Value Engineering

Final Report

Grand Valley Irrigation Company Fish Screens

February 28, 2000

Figure 11. Overview Plan Proposal No. 6.

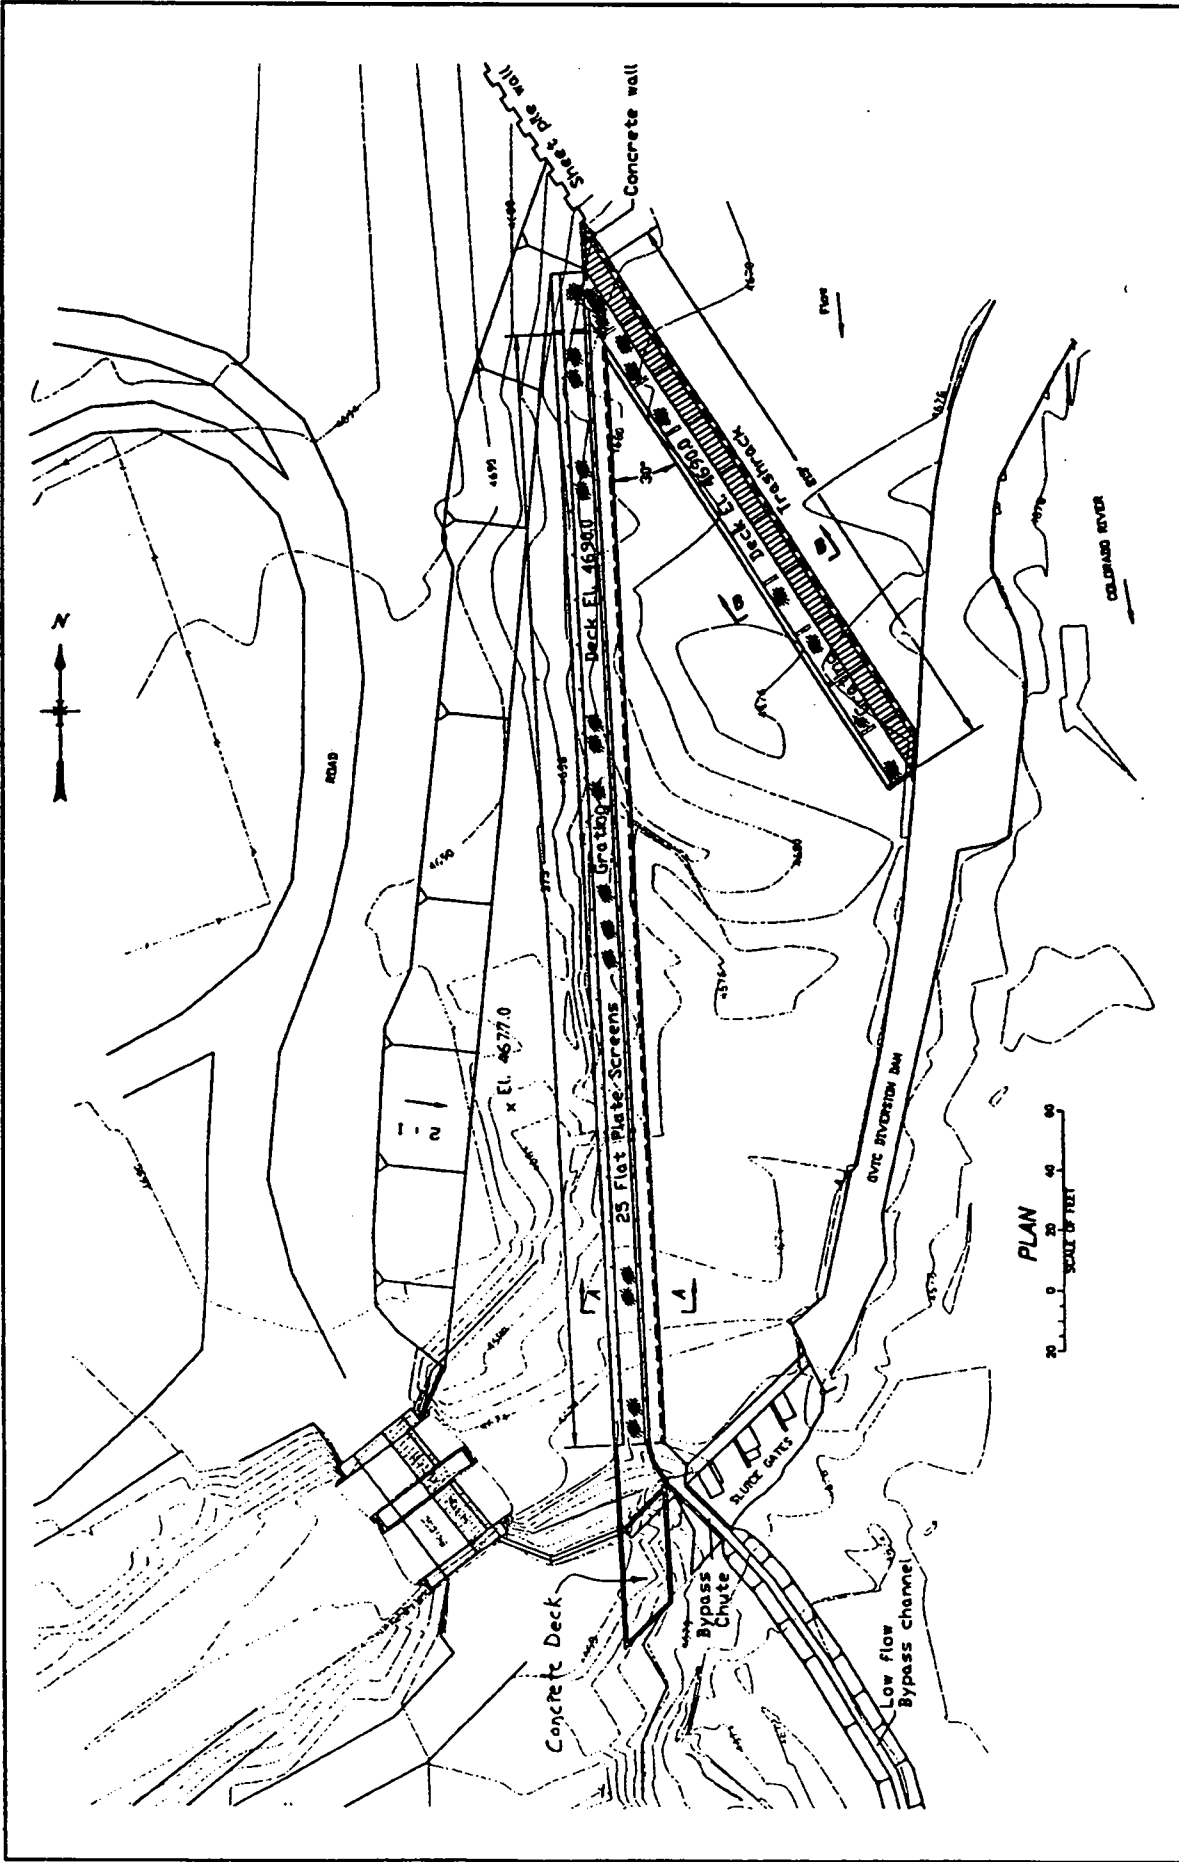
- Proposal Description: Option E would place all components in the river upstream (outside) of the Grand Valley Irrigation Company facilities, as shown in Figure 11.
- Critical Items to Consider: Location, depth, maintainability and unknown factors.
- Ways to Implement: Study in more detail and redesign to: include refinements to enclose the gap between the deck and the flood gates, improve trash deflection, and clarify access. May require baffling. Requires multiple squeegees to clean.
- Changes from the Baseline Concept:
 - . River volume and flows considerably higher than would be experienced in the canal.
 - . Significantly larger, more complex and more expensive facility.

Figure 12. Overview Plan Proposal No. 7.

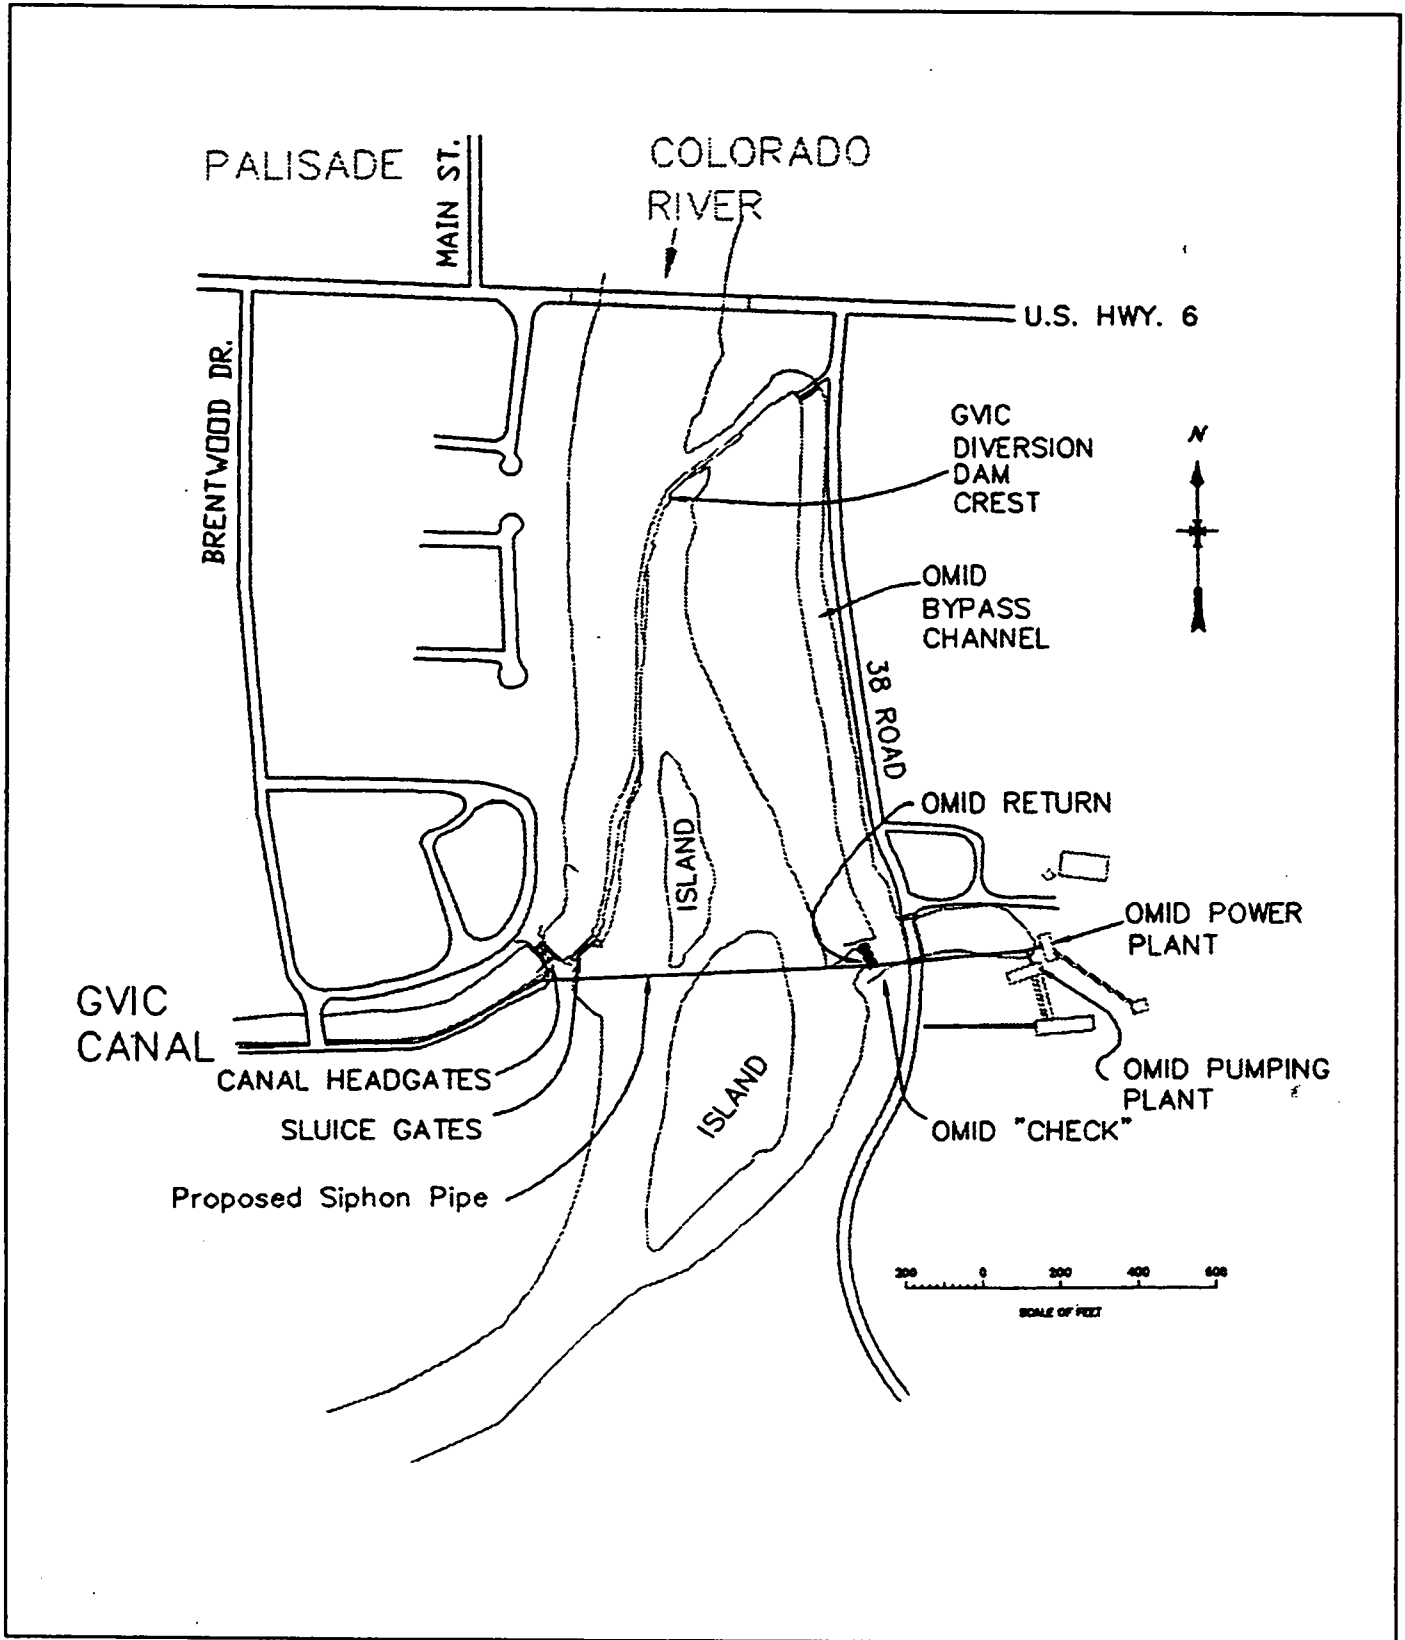
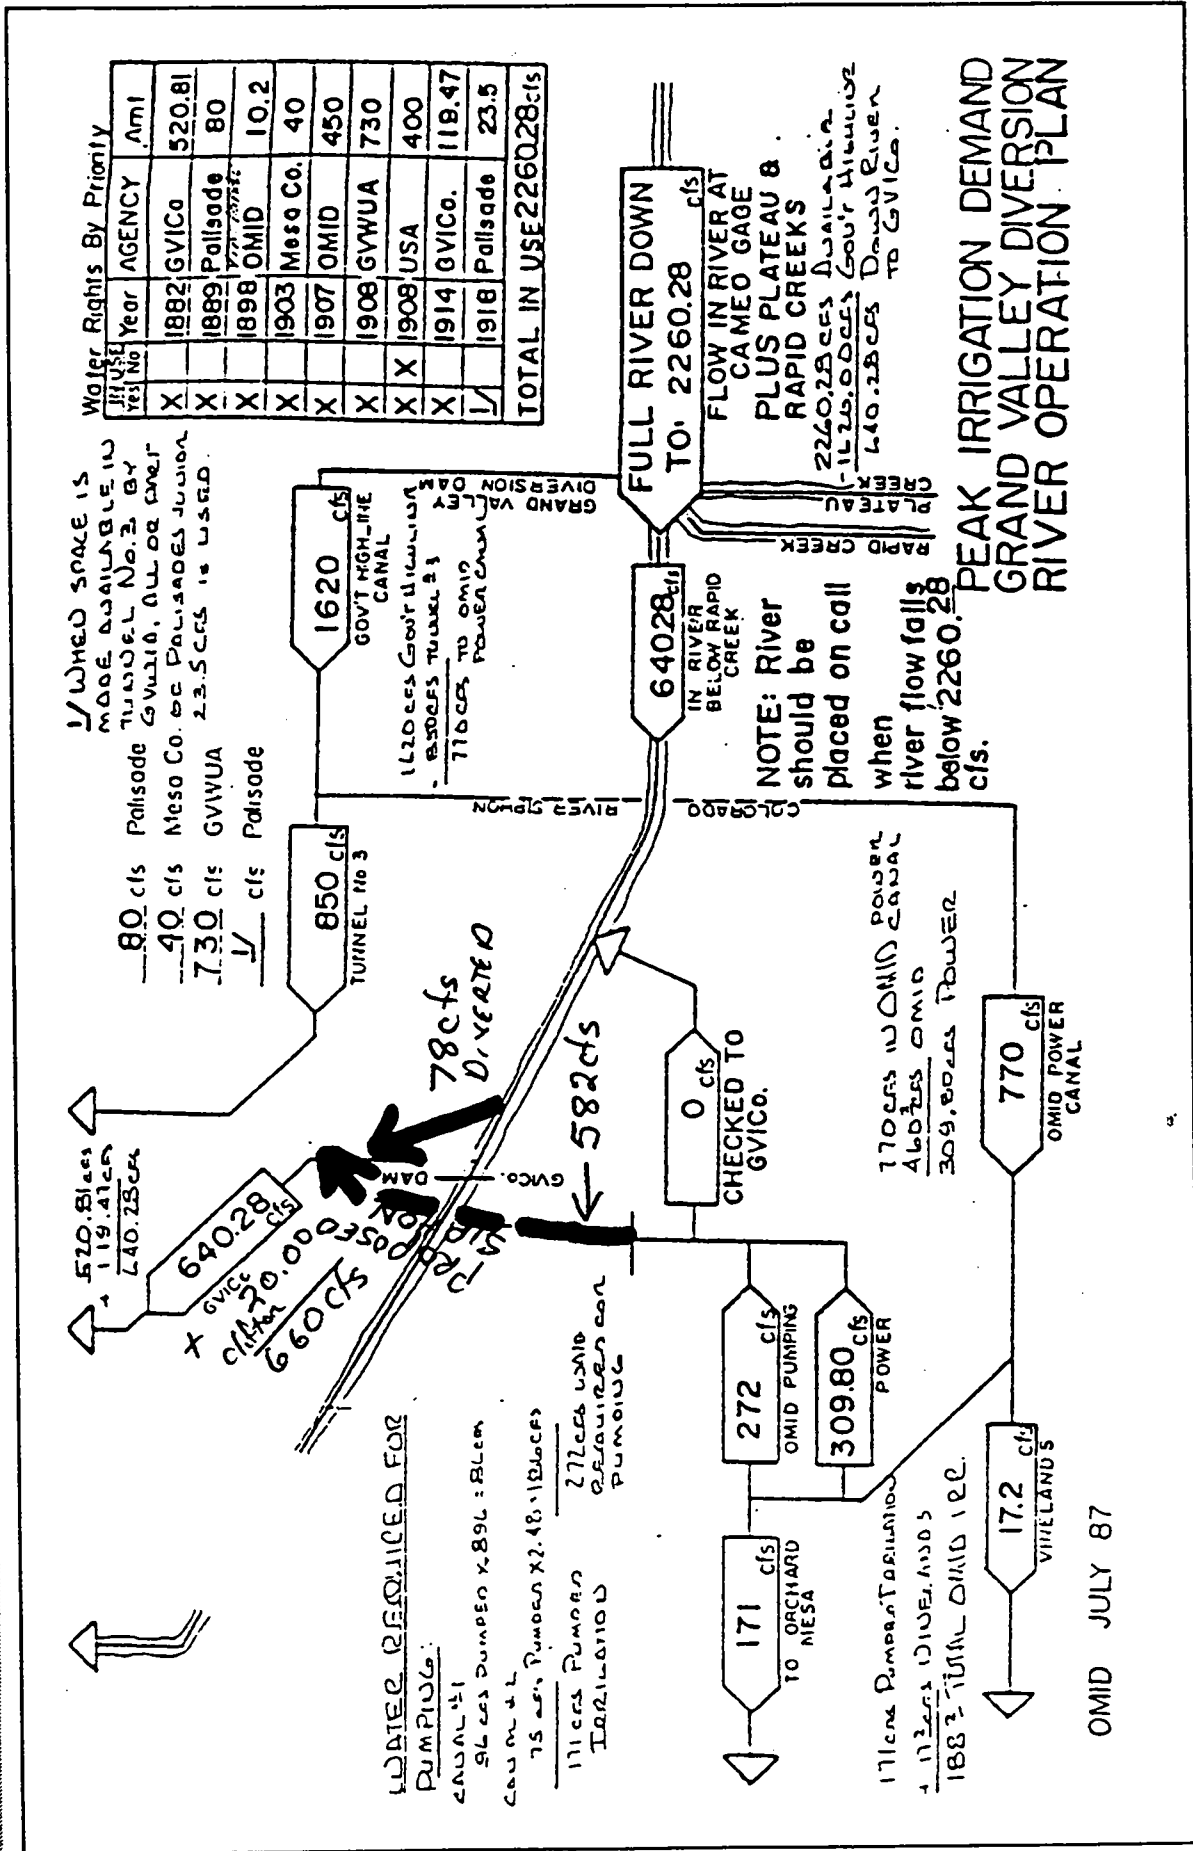
The OMID power canal, powerplant and hydraulic turbine pumping plant are across the river east of the GVIC headworks. The OMID power canal and powerplant each have a capacity of approximately 777 cfs. Typically OMID runs 310 cfs through the powerplant during the irrigation season. The remainder of the flow, 443 cfs, runs through the hydraulic turbine pumping plant to lift 171 cfs to the Orchard Mesa conveyance system. It is assumed that 582 cfs (310 cfs plus 272 cfs) is available to siphon across the river to the GVIC canal from the tailwater areas. (See Figure 13). At low river flows, OMID has a check structure which forces the water to back upstream to a point above the upper portion of the GVIC diversion dam. It is assumed that the resulting tailwater surface elevation during this checking has a slight impact to the efficiency (decrease in head) of the powerplant and pumping plant, but this is still in an acceptable operation range.

- **Critical Items to Consider:**
 - . Impacts to existing agreements between OMID and U.S. Fish and Wildlife Service.
 - . Reduced efficiencies on power and pumping plants from continuous high tailwater.
 - . Is this a change in the point of diversion for GVIC and impact to existing water rights?
 - . Administration of water rights by State Water Engineer.
 - . Consider how to divert flow when OMID is not operating.
 - . Rotating belt screen on the headworks to supply the remaining 80 to 100 CFS.
 - . Consider increasing the intake into the Highline Canal to produce the total flow (660 CFS) required by GVIC.

- Ways to Implement:
 - . Construct inlet structures at the discharge points of the power and pumping plants.
 - . Construct a siphon across the river.
 - . Construct a siphon outlet in the canal.
 - . Install two small traveling belt screens on existing canal headworks.
- Changes from the Baseline Concept:
 - . Substantially reduces quantity of flow to be screened and eliminates proposed trashrack.

Figure 14. Overview Plan Proposal No. 8.

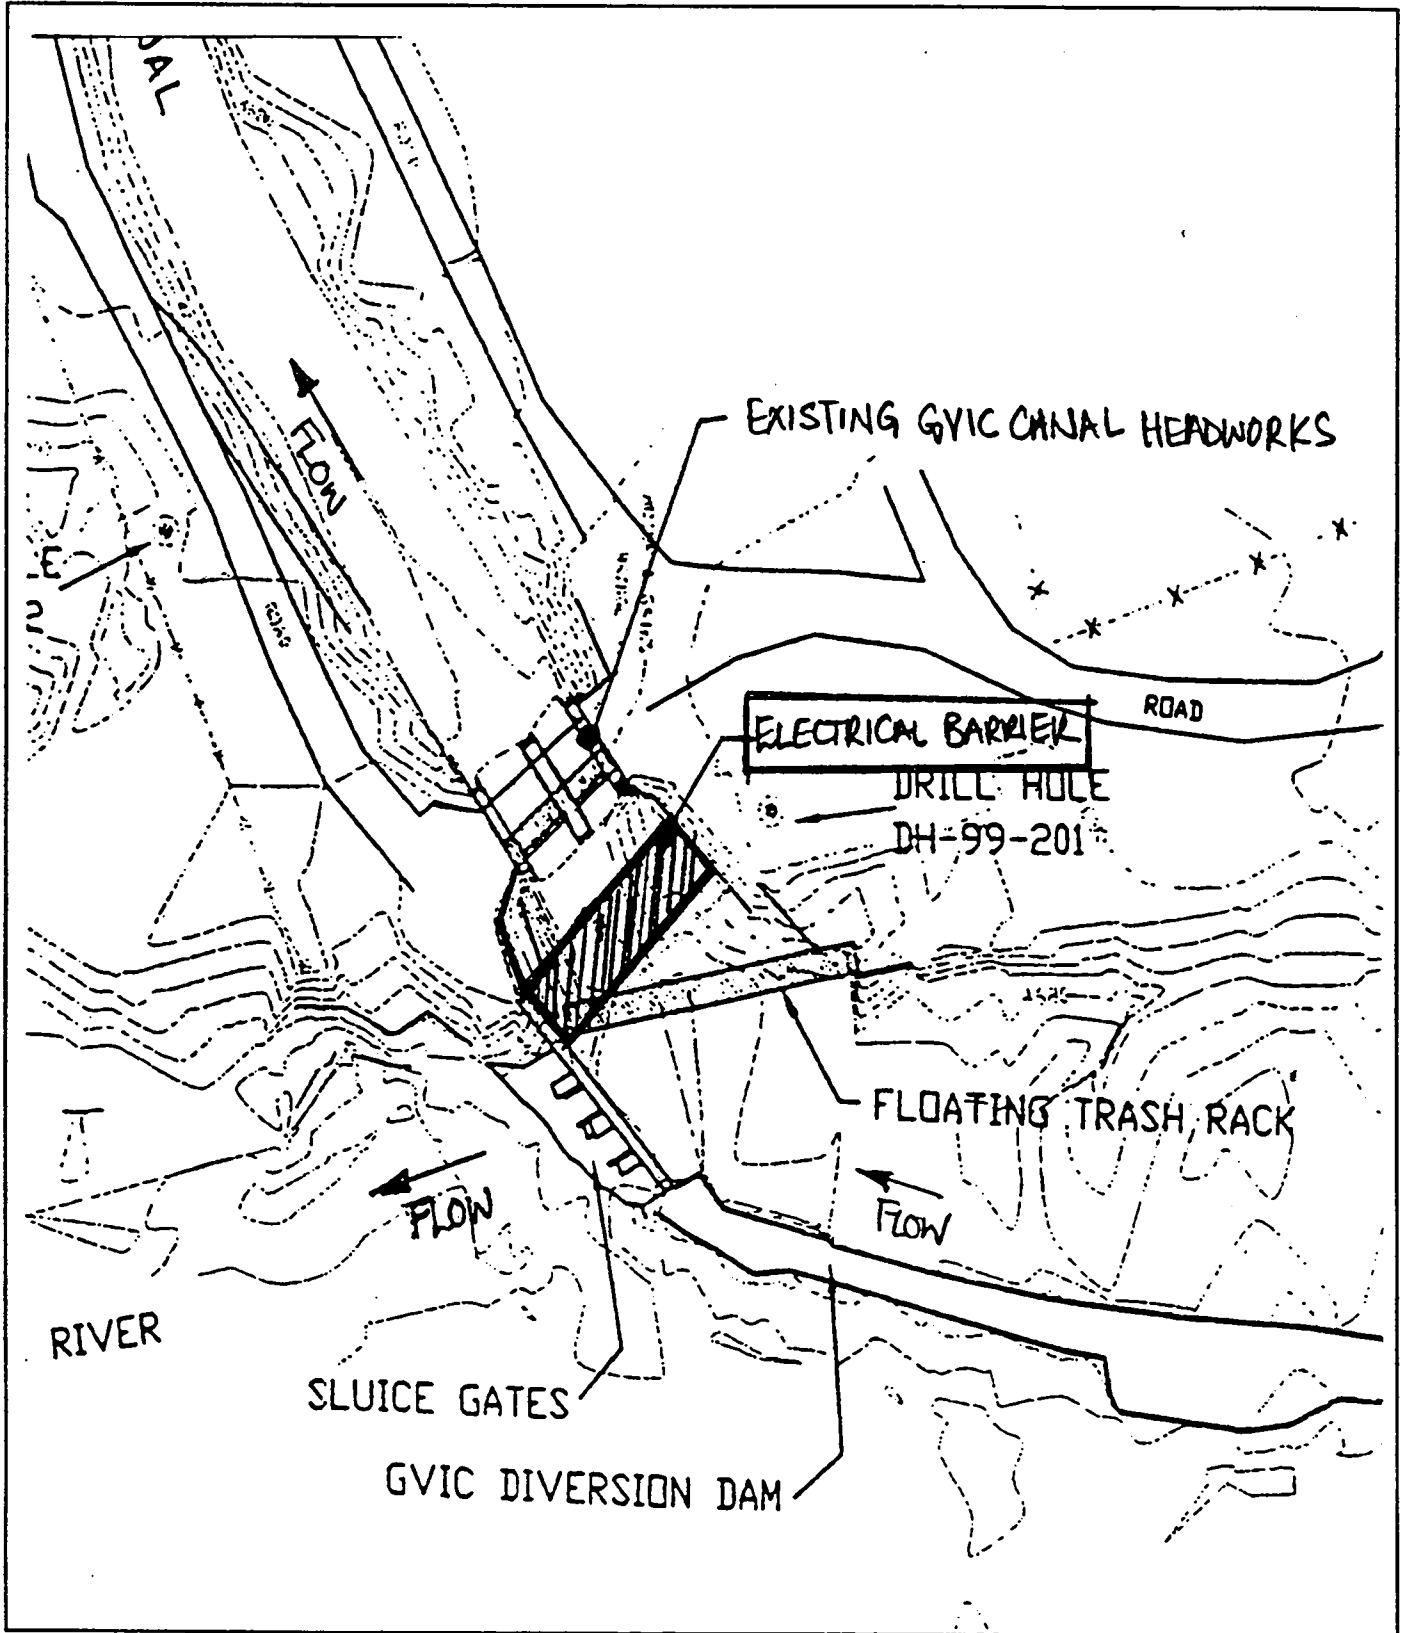
- **Proposal Description:** An electrical barrier would be used instead of a positive barrier fish screen structure to exclude fish from GVIC diversion flows at the existing GVIC Diversion Dam Canal Headworks. The barrier would be located in-river and upstream of the existing head gates (Figure 14). The barrier would be designed and constructed to minimize or eliminate the entrainment of adult and juvenile target species (Colorado Pikeminnow and Razorback Sucker). The barrier can be oriented at an angle with respect to the existing headworks structure to create a barrier that fish could sense and avoid. Adequate sweeping flow for guidance past the barrier could be provided using the existing diversion dam floodgates during times when sufficient river flow is available. However, low flow periods would likely represent a limiting case when the electrical barrier performance is less than optimal. During these periods the barrier could be shut down or remain operating. Debris and trash would be handled in the same manner as with the existing facility (i.e., no additional debris removal facilities are required).

- Could represent a public safety hazard.
- Target species behavior may not be conducive to application of electrical barriers (i.e., ineffective for exclusion, causes injury to fish, etc.)
- Long term O&M is a question.
